Moorebank Precinct West - Stage 2 Proposal

Response to Submissions - SSD 16_7709

Response to Submissions Report

SSD16-7709

Figure 6-1: Amendments to the Proposal

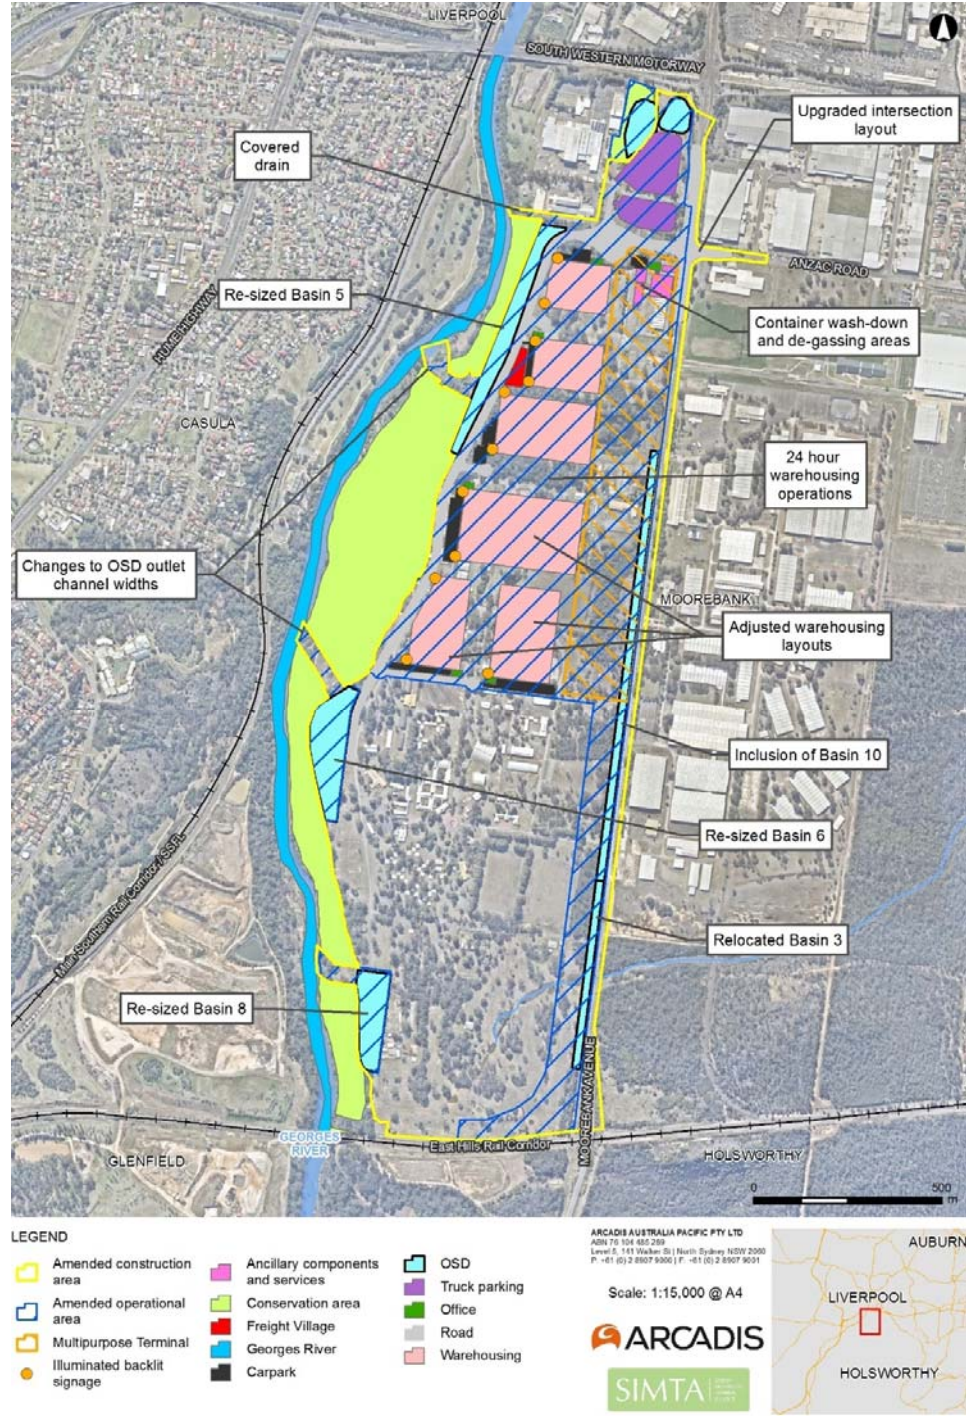
The amendments to the Proposal are detailed in the below sections and are shown in Figure 6-1.

The temporary basin 3A identified in the EIS would be relocated to the Moorebank Avenue frontage and renamed as Basin 3, refer to Figure 6-1 and Appendix H of this RtS. Basin 3 would be established during the construction of the Amended Proposal (as a sediment basin), however would be utilised as a permanent OSD during operations of the Amended Proposal. Basin 3 would discharge via an existing culvert under Moorebank Avenue in an easterly direction into Anzac Creek.

Figure 6-3: Moorebank Avenue/Anzac Road upgraded intersection layout

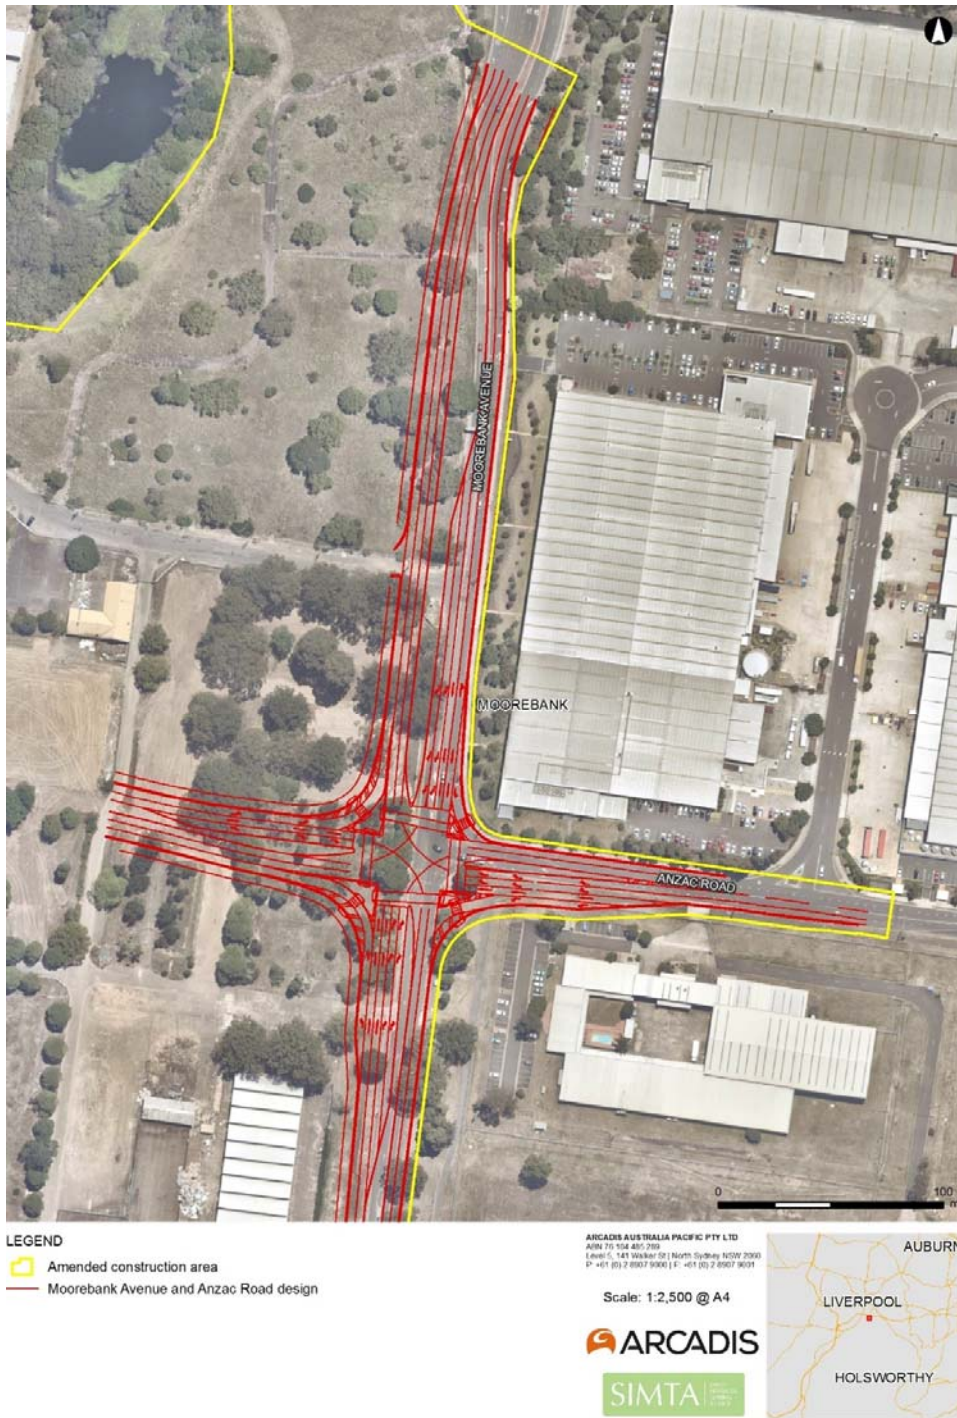
Refer to Figure 6-3 for intersection layout details.

This intersection would have the capacity to accommodate A-Double vehicles, i.e. vehicles capable of moving two 40 foot containers.
